PD Modification Application: PRS 26-0473

Modification requests are for only Pod 24A. The minor modification proposes three (3) access connections to the subject modification area (folio #54244.0082) located at the northeast corner of 19th Ave. NE and Turnbuckle Dr. More specifically, this includes the addition of two right-in / right-out access points and one cross access point for shared access as depicted on the site plan included with this application. The cross access will be shared with the property abutting the project site to the east and will include a full access connection to Myers Glade. There is a corresponding update to the conditions of approval establishing site specific development standards.

AGENCY REVIEW COMMENT SHEET

2.5 Proposed Site Plan

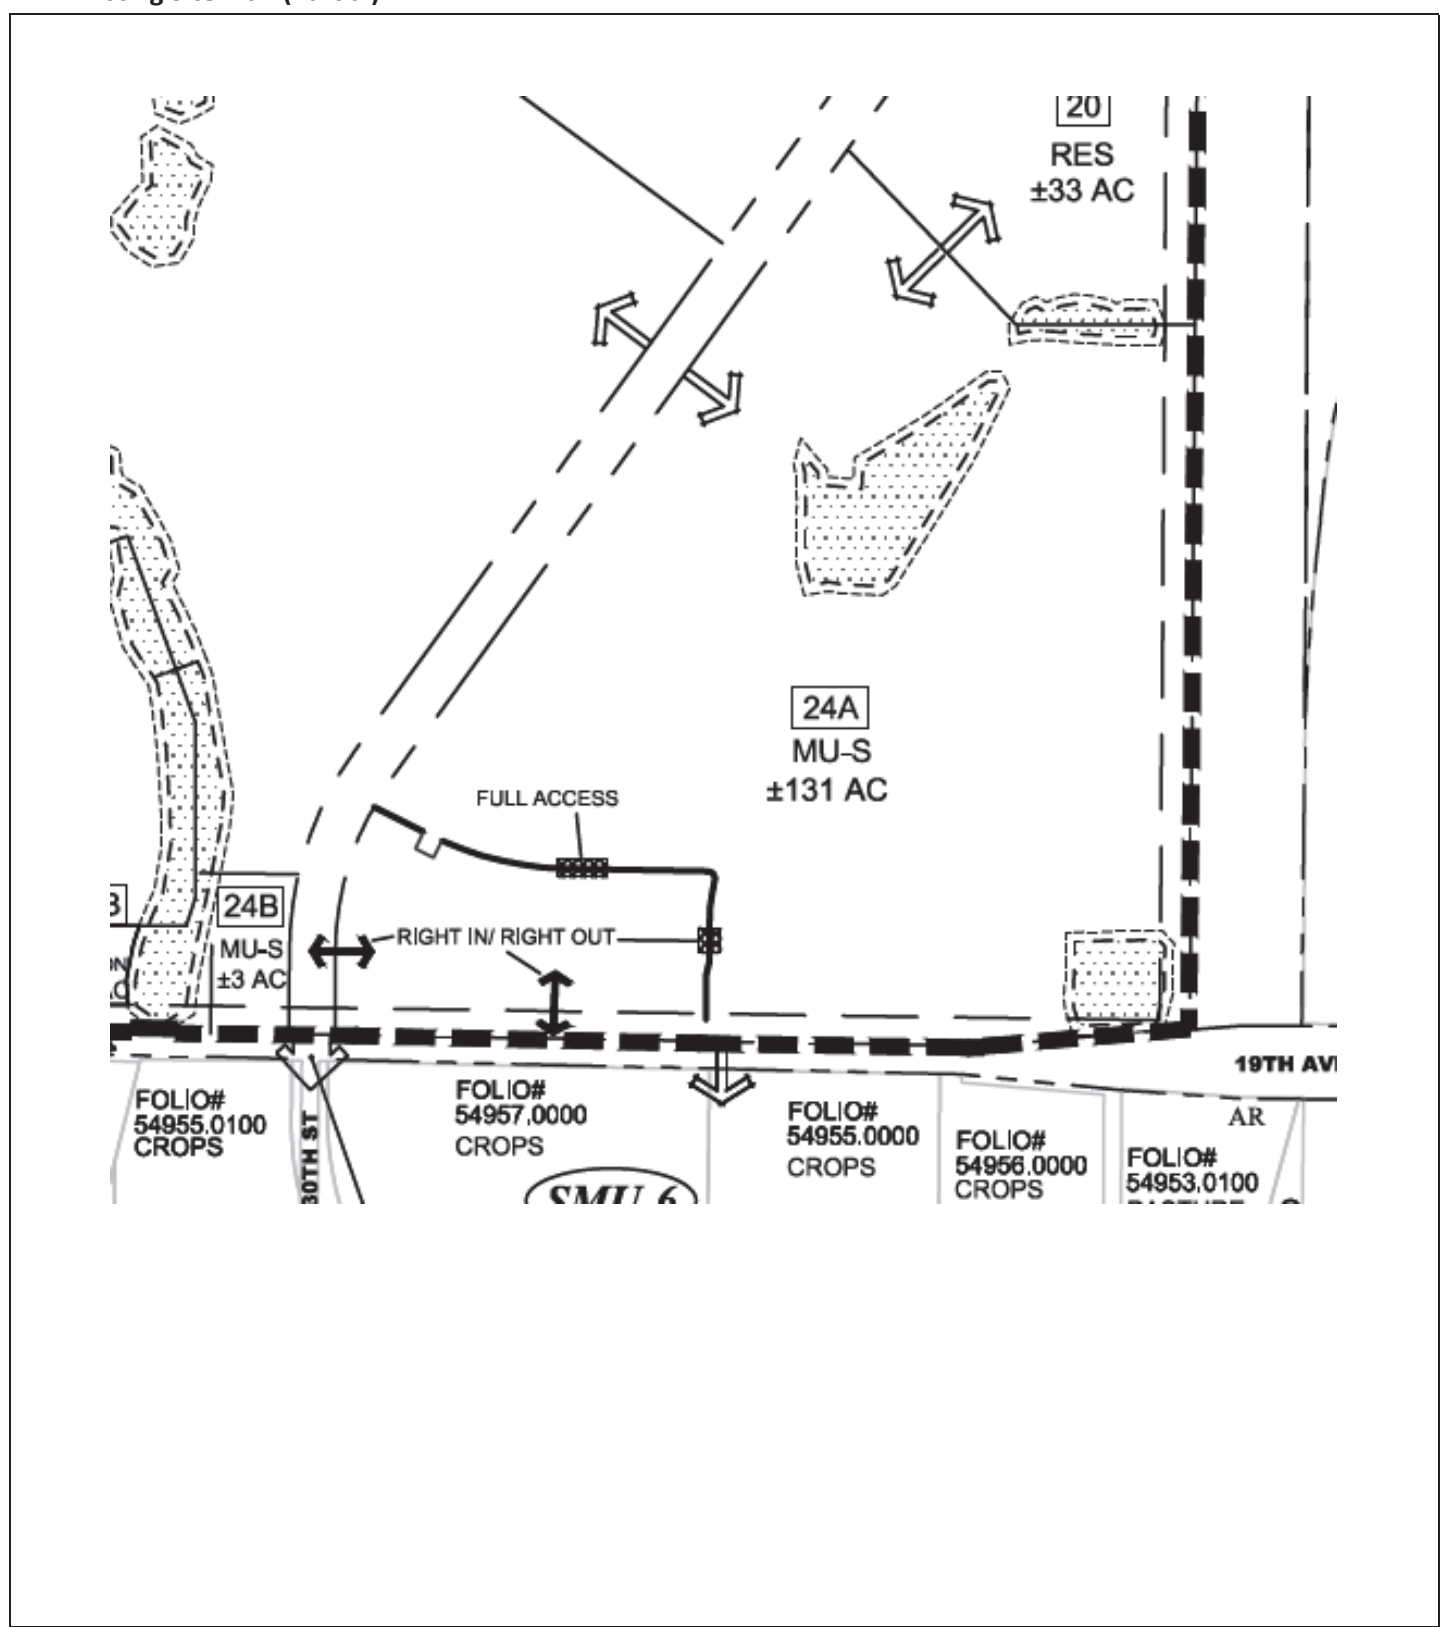
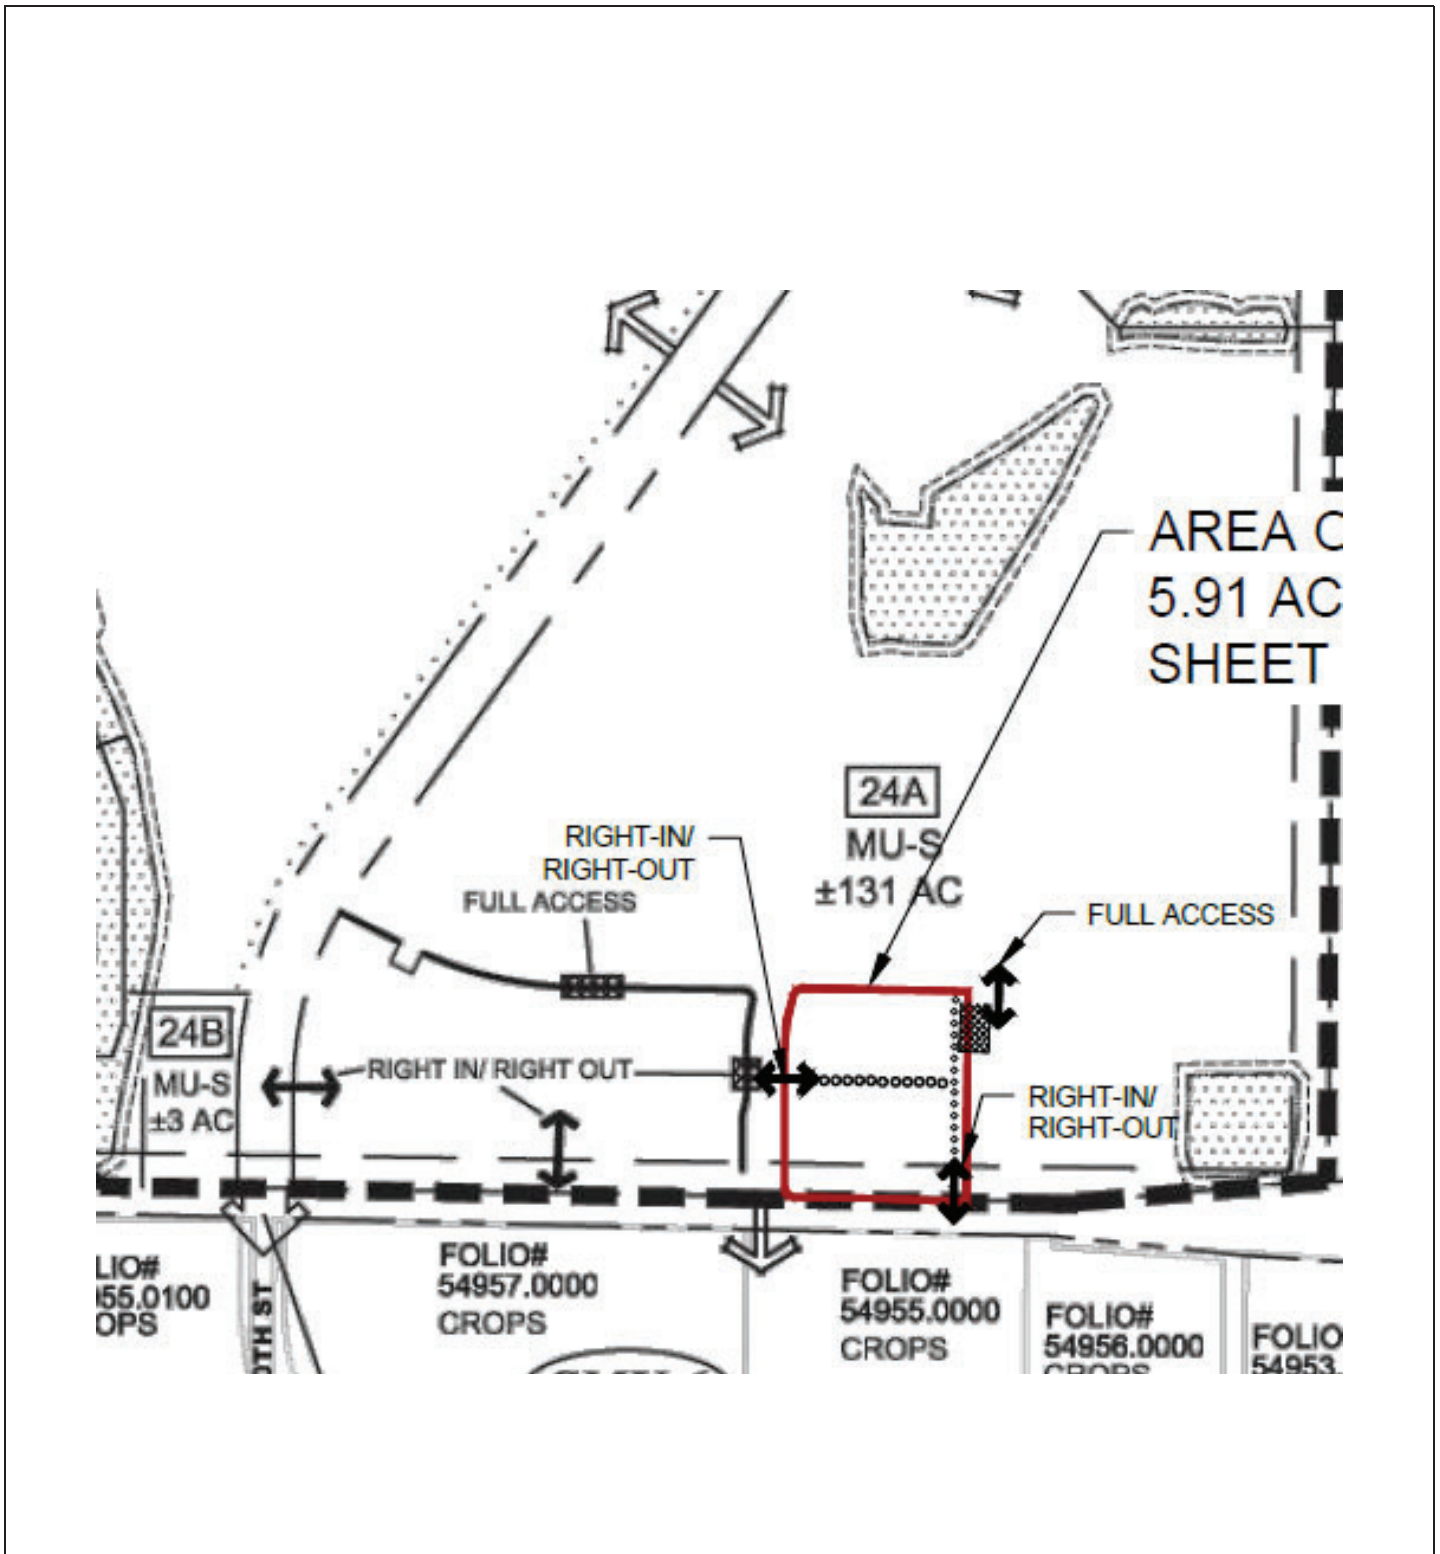
The applicant is proposing to modify the approved site plan as it pertains to the development of Folio #54244.0082, for the addition of two right-in / right-out access points and one full access via a shared access facility as depicted on the site plan submitted with this application. The applicant is also proposing Development standards for the parcel.

In addition, Retail and Office design standards for Folio 54244.0082 are proposed to be removed. The design standards being removed apply to the seven (7) Mixed Use and Town Center tracts located throughout the larger PD and provide for traditional neighborhood designs type standards. With the parcel located at the southern end of the PD along 19th Ave NE with commercial and industrial uses across from the parcel on the south side of 19th Ave NE staff does not object to removal of these standards for this parcel.

Staff finds the request Approvable, subject to the following conditions listed below, and based on the general site plan submitted April 14, 2026.

FIGURE 1

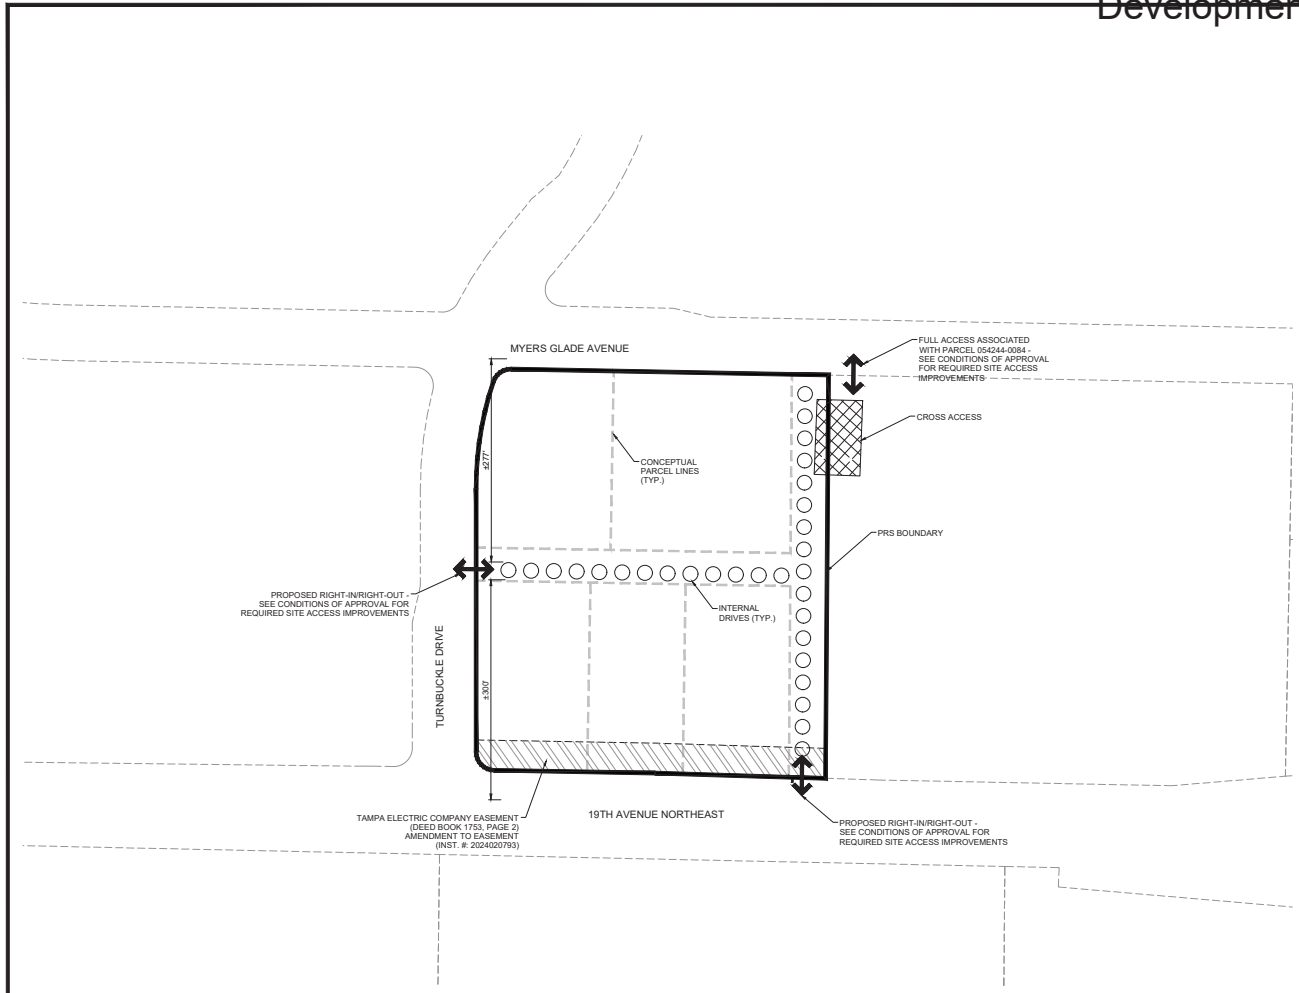
The request is to add one (1) right-in/right-out access to 19th Avenue.

The request is for an Administrative Variance to Section 6.04.03I of the Hillsborough County LDC for the number of accesses to serve the project. As shown in Table 4, 2 accesses would be allowed for the current development plan. An additional access to 19th Avenue is proposed.

- 1) The proposed access to 19th Avenue meets the access spacing criteria per the LDC.
- 2) The access is to be limited to right-in/right-out access which will be designed to include a median within 19th Avenue to restrict the movements.
- 3) A westbound right turn lane is proposed to be provided for the right-in/right-out access so as not to impact westbound traffic on 19th Avenue.
- 4) The location of the access to 19th Avenue meets the stopping sight distance from the I-75 overpass on 19th Avenue, as shown in Figure 1.
- 5) The additional access allows for the better distribution of the project traffic to the accesses serving the project.

The attached AV is **Approvable** to me, please include the following people in your response:
